## 10219 Land at Valley Park, Didcot

### Technical Note 36: Design Rationale and further Amendments – Southern Roundabout Access

Dated 26<sup>th</sup> April 2021.

B4493 Southern Site Access  
Proposed Roundabout - Planning

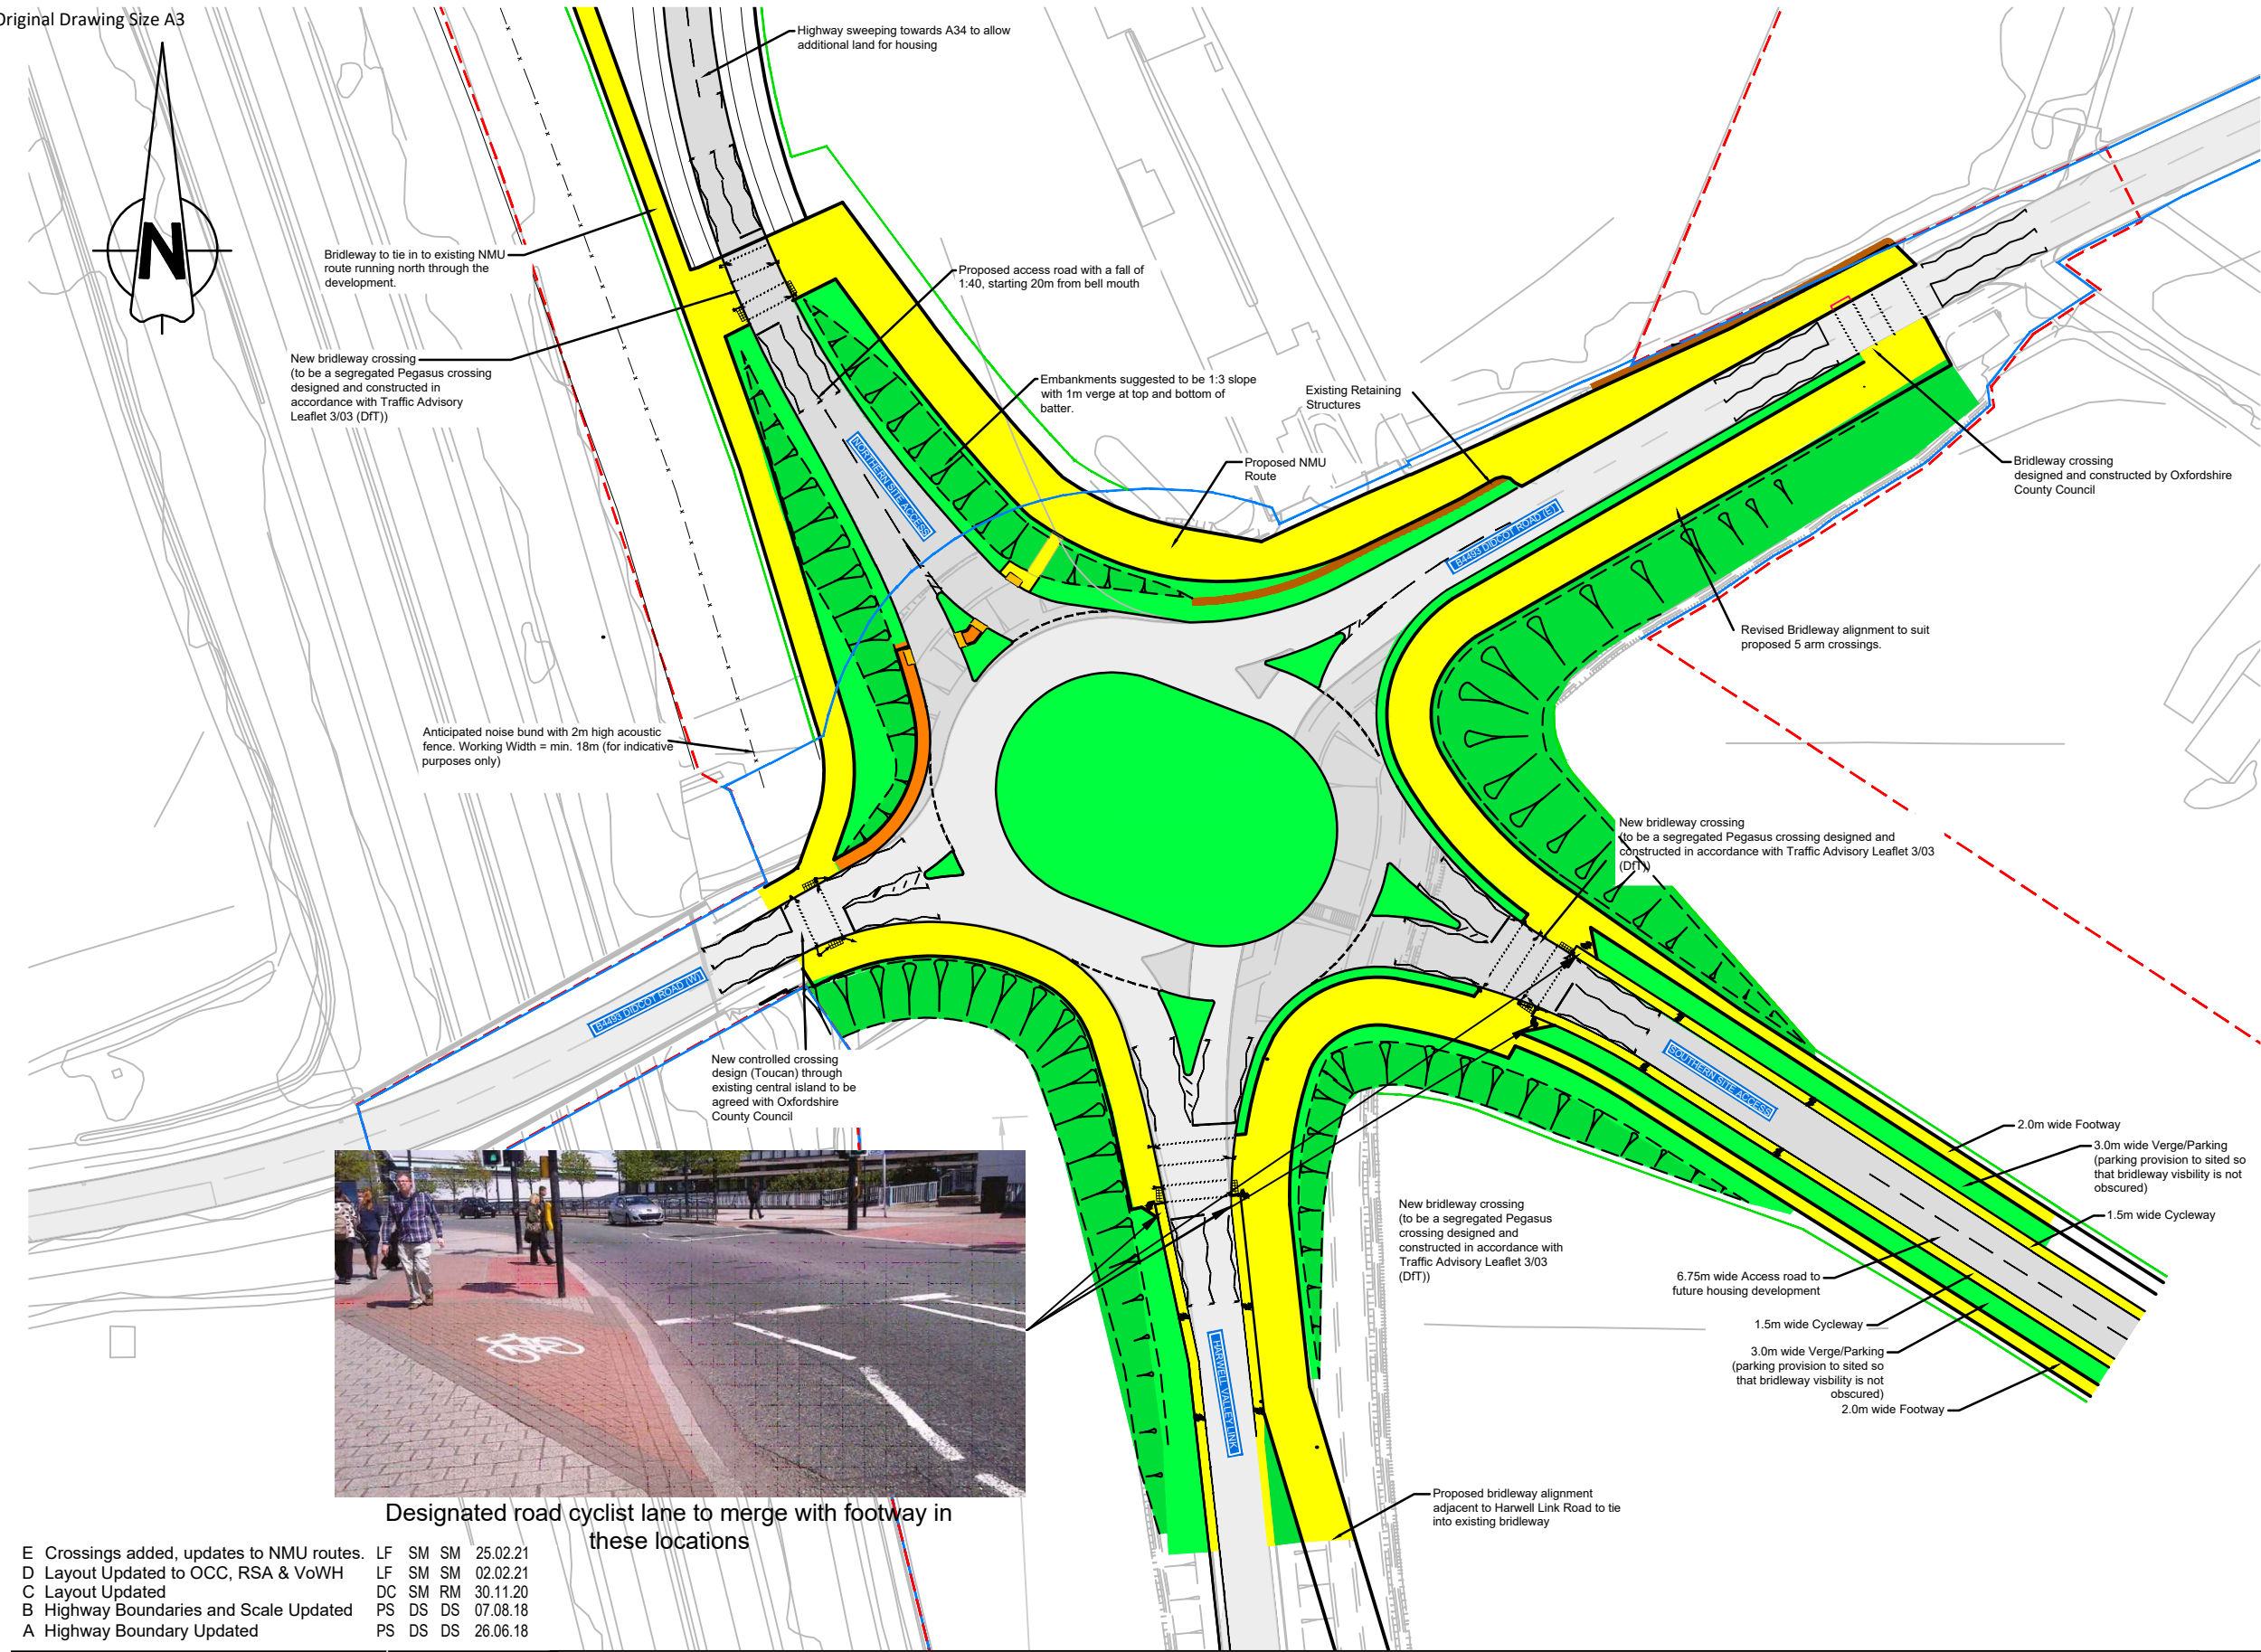
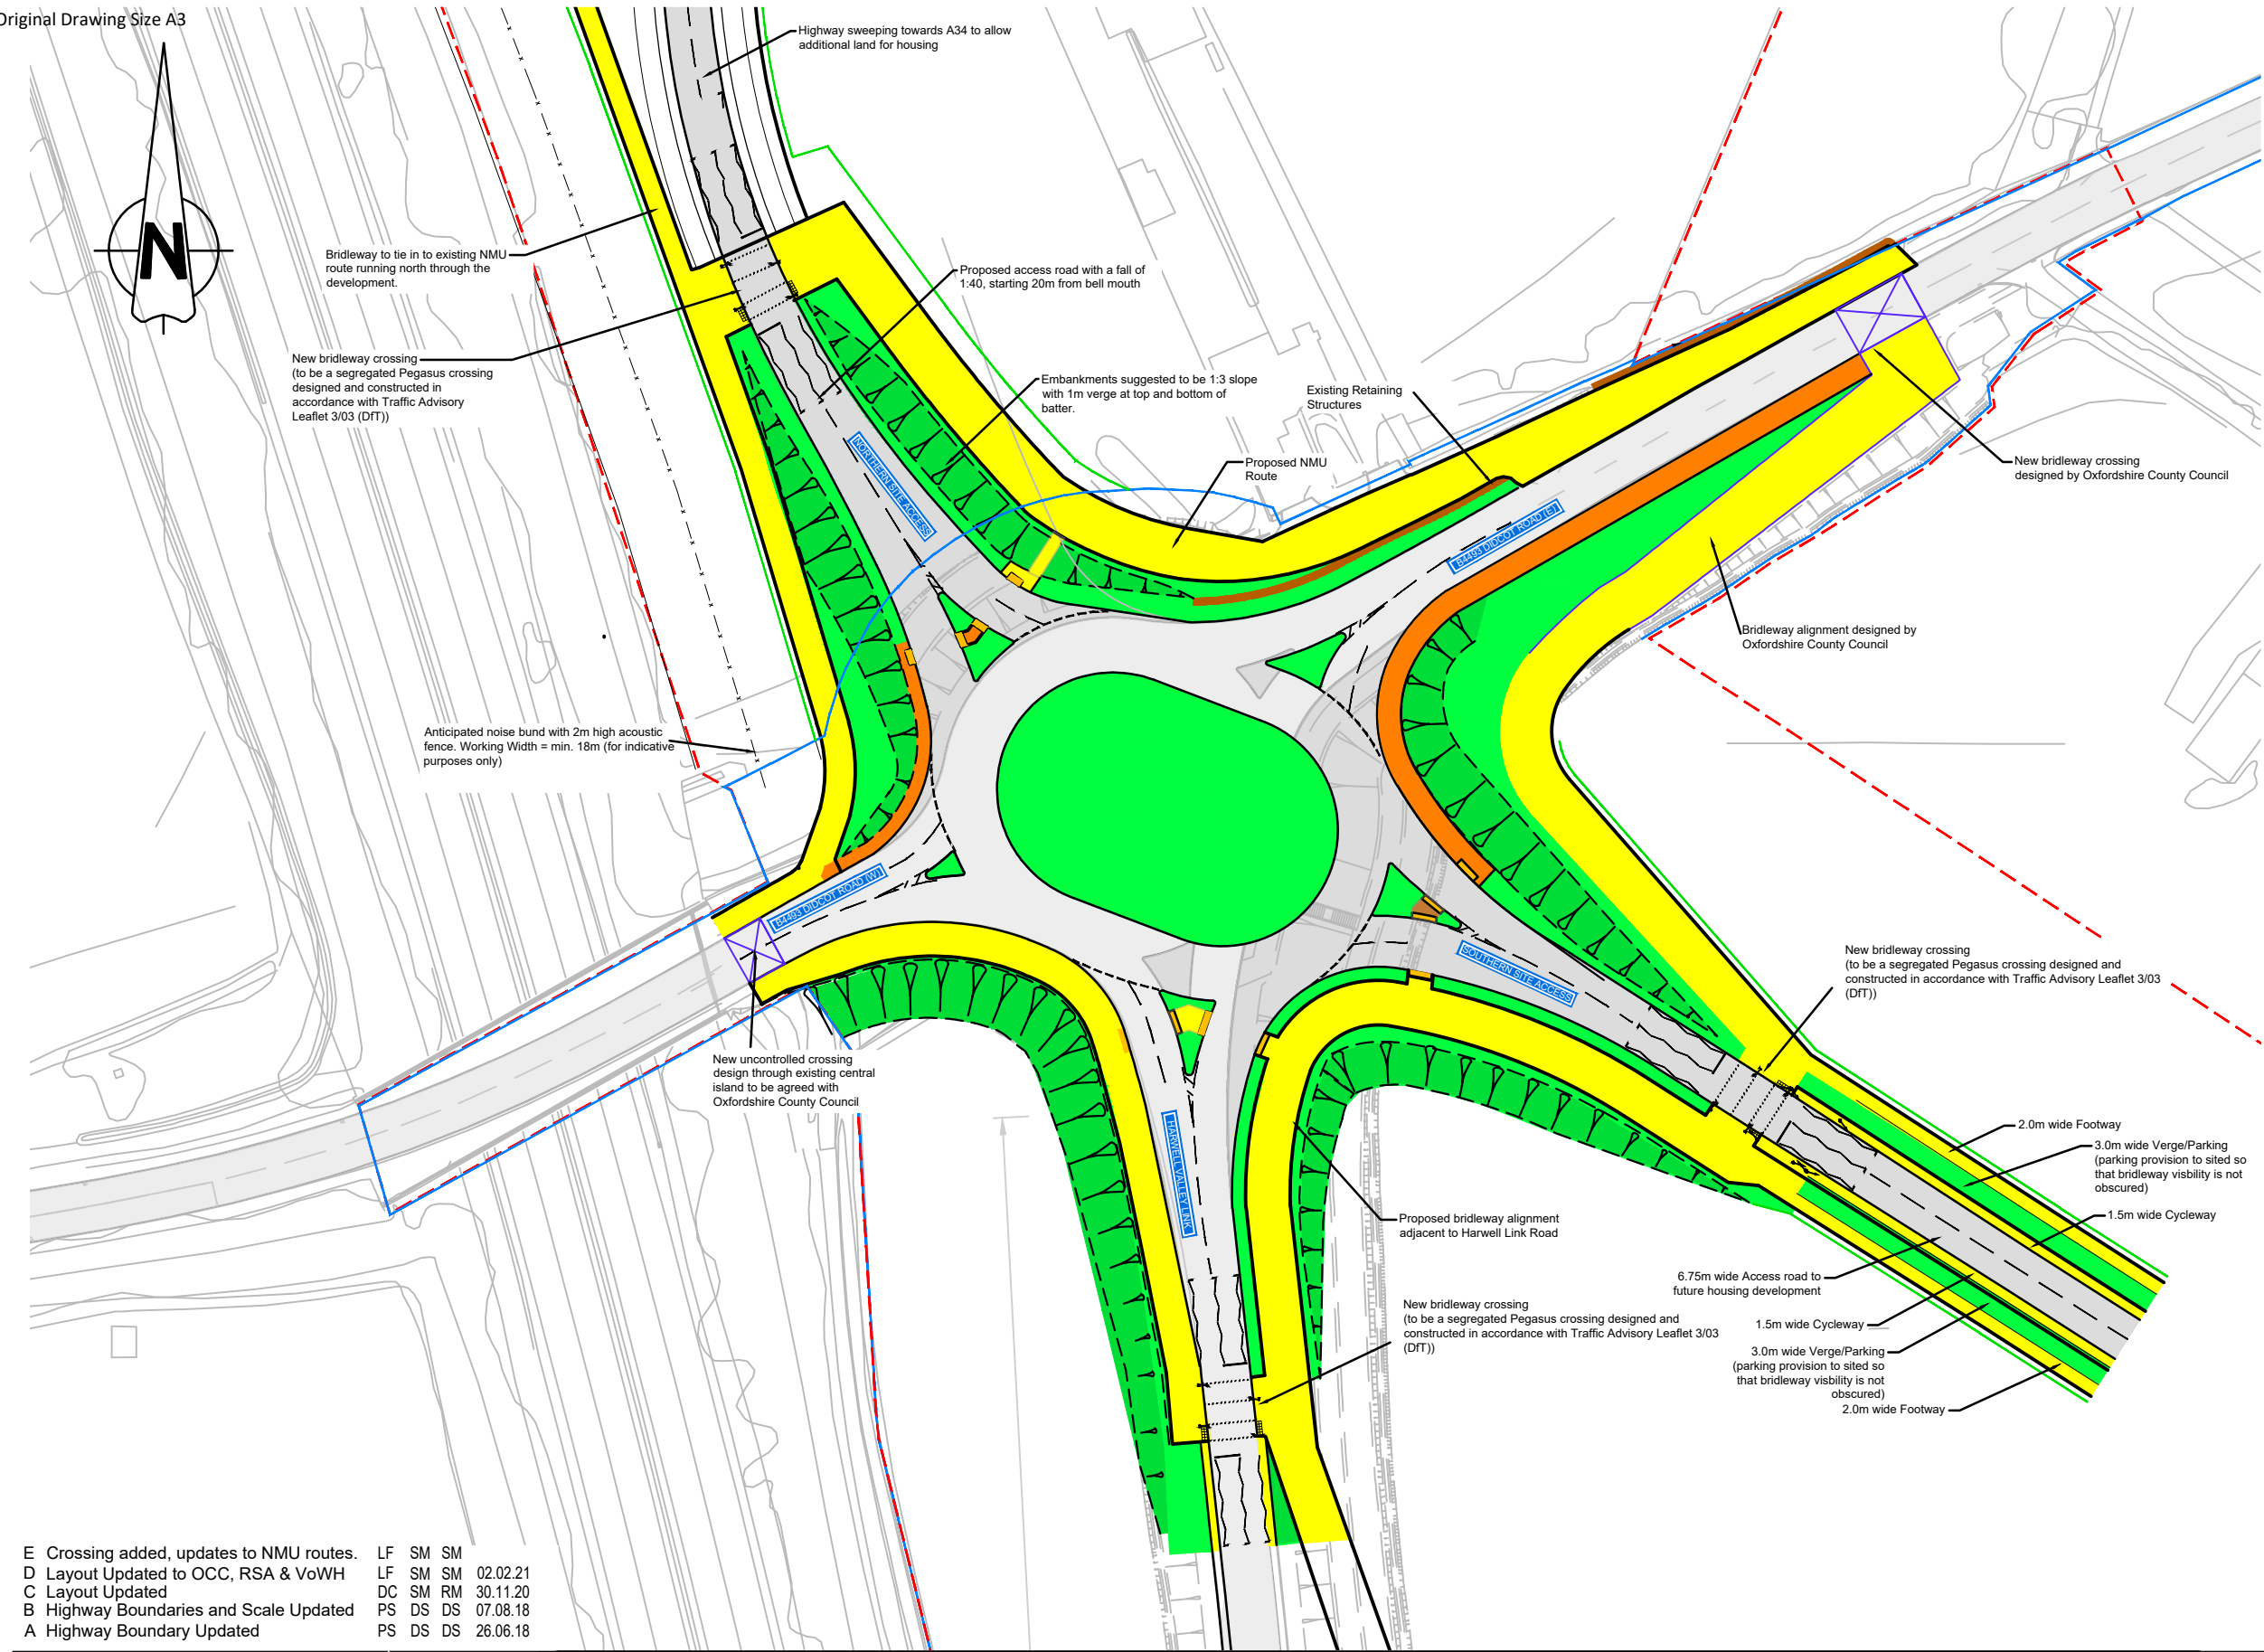
- 4.4** That through continued analysis, further modifications of the design could be done within context of the above standards to improve amenity by moving the controlled crossing closer to the main circulatory carriageway and add further controlled priority for non motorised users on the remaining 2 arms with improved width provisions on the segregated facilities, where room allows. These arms did not have facilities on the previous design.

E Crossings added, updates to NMU routes.	LF	SM	SM	25.02.21
D Layout Updated to OCC, RSA & VoWH	LF	SM	SM	02.02.21
C Layout Updated	DC	SM	RM	30.11.20
B Highway Boundaries and Scale Updated	PS	DS	DS	07.08.18
A Highway Boundary Updated	PS	DS	DS	26.06.18
